Re: CPO: Blanchardstown Bus Corridor, Case Reference: KA29N.313961

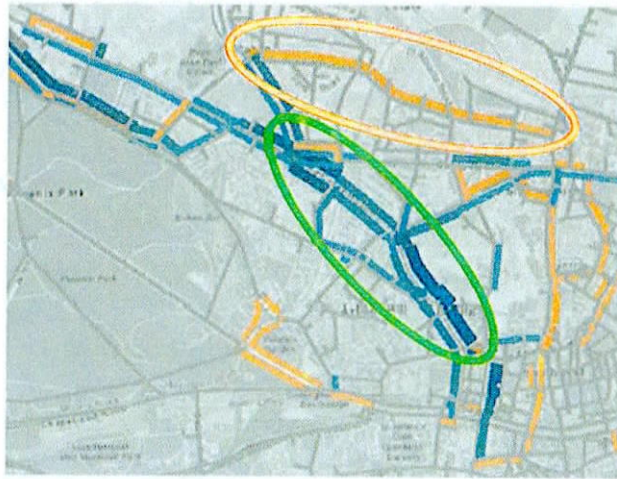
There are three road restriction changes proposed in the CPO application for the Blanchardstown Bus Corridor, none of which were set out in any of the proposed designs issued for public consultation since the Bus Connects project commenced in 2018.

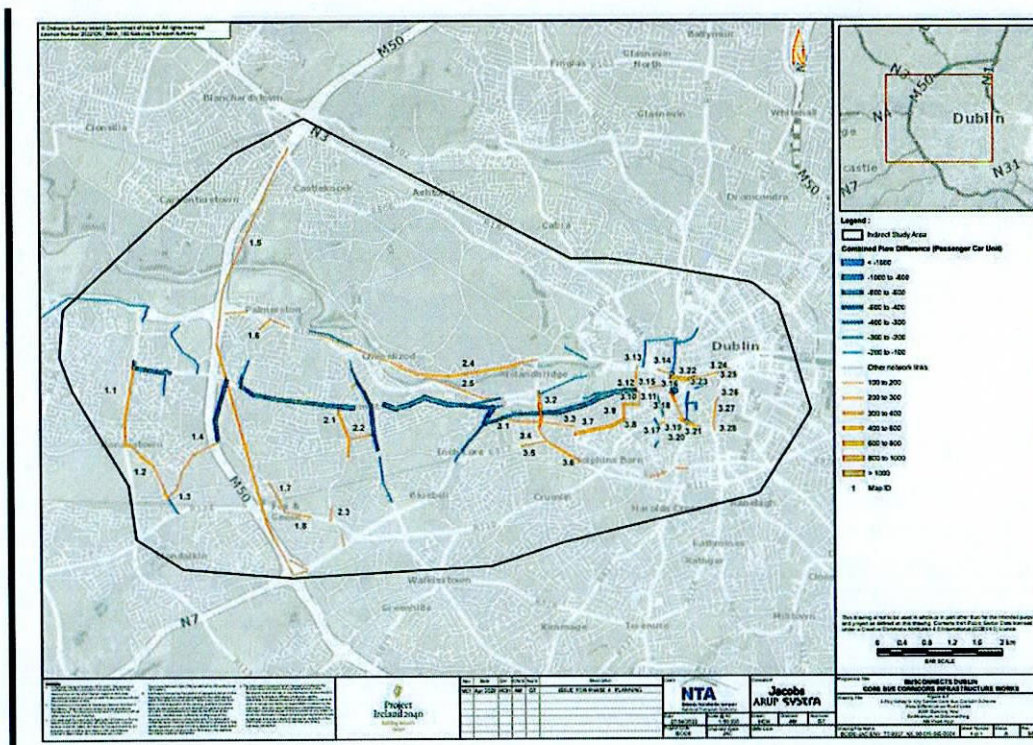
- **Flawed classification system of the impacts which sees areas forecast to experience an 80% increase in traffic flows being described as a “low impact” change.** In appendix A6.4 of the EIAR, Impact Assessments, the following are estimated when comparing a “Do Minimum” with a “Do Something” (i.e., BusConnects) scenario at PM peak hour:
 - An 80% increase in hourly traffic flows at the junction of Connaught Street and Shandon Crescent,
 - A 55% increase in hourly traffic flows at the junction of Fassaugh Ave and Dingle Road,
 - A 64% increase in hourly traffic flows at the junction of Fassaugh Ave and Bannow Road.

Each is described as having “not significant” effect and “negligible” impact. I can tell you as a resident of Connaught Street there is no way that changes of this nature can be considered “not significant” and “negligible” in their impacts on our abilities to go about our daily lives and live in a safe environment!

Furthermore, there is an estimated 70% increase in peak hourly traffic flows at the junction of Connaught Street and St Peter’s Road. This was described as being a “low impact” with “moderate” effect. It appears that only areas that are forecast to experience increases in traffic volume to beyond 85% of road capacity are classified as having any impact at all.
